Access Compliance Report

Public Rights-of-Way

Intersection ID: N/A	Main Street: CHISWICK_RD	Cross Street: BARWICK_RD	Location: W
ADA ID: 64EC4E1E3652	Ramp Type: PerpDiag	Initial Pass/Fail: Fail	Overall Compliance: No
		Severity Score: 25

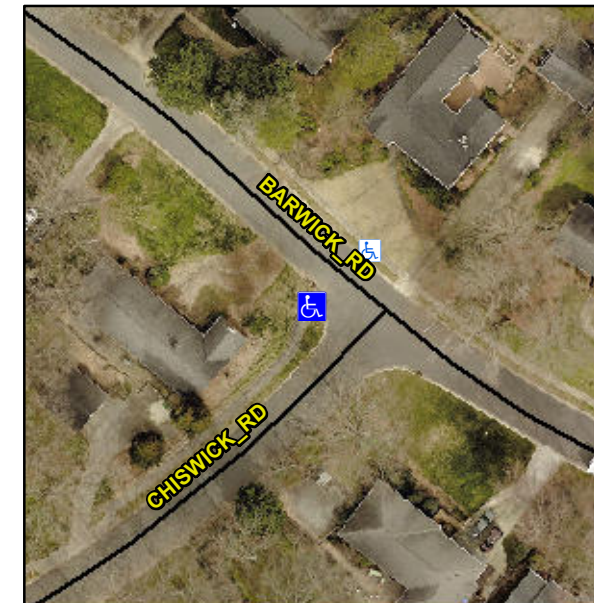
Not Found, R304.2.2

Compliance	Description	Data	Compliance	Description	Data
N/A	Ramp Length (in)	73.0	No	Ramp Slope (%)	13.5
Yes	Ramp Width (in)	48.0	Yes	Ramp XSlope (%)	2.0
N/A	Flare Type LT	N/A	N/A	Flare Type RT	N/A
N/A	Flare Slope LT (%)	N/A	N/A	Flare Slope RT (%)	N/A
N/A	Flare Traversable LT?	N/A	N/A	Flare Traversable RT?	N/A
N/A	Landing Length (in)	N/A	N/A	DWS Provided?	N/A
N/A	Landing Width (in)	N/A	N/A	DWS Contrast?	N/A
N/A	Landing Slope (%)	N/A	N/A	DWS Length (in)	N/A
N/A	Landing X Slope (%)	N/A	N/A	DWS Full Width?	N/A
N/A	Landing Curb? (Y/N)	N/A	N/A	DWS Offset (in)	N/A
N/A	Shared Landing?	N/A			
N/A	Gutter Ponding?	N/A	N/A	Gutter Slope (%)	N/A
N/A	Gutter Lip Ht (in)	N/A	N/A	Gutter X Slope (%)	N/A
N/A	Painted X Walk1?	No	N/A	Painted X Walk2?	No
	X Walk 1 Direction	To SE		X Walk 2 Direction	To NE
N/A	X Walk 1 Width (in)	N/A	N/A	X Walk 2 Width (in)	N/A
	X Walk 1 Slope (%)	1.7		X Walk 2 Slope (%)	0.4
	X Walk 1 X Slope (%)	4.8		X Walk 2 X Slope (%)	0.9

Remove & Replace Curb Ramp With Two New Directional Ramps or Equivalent.
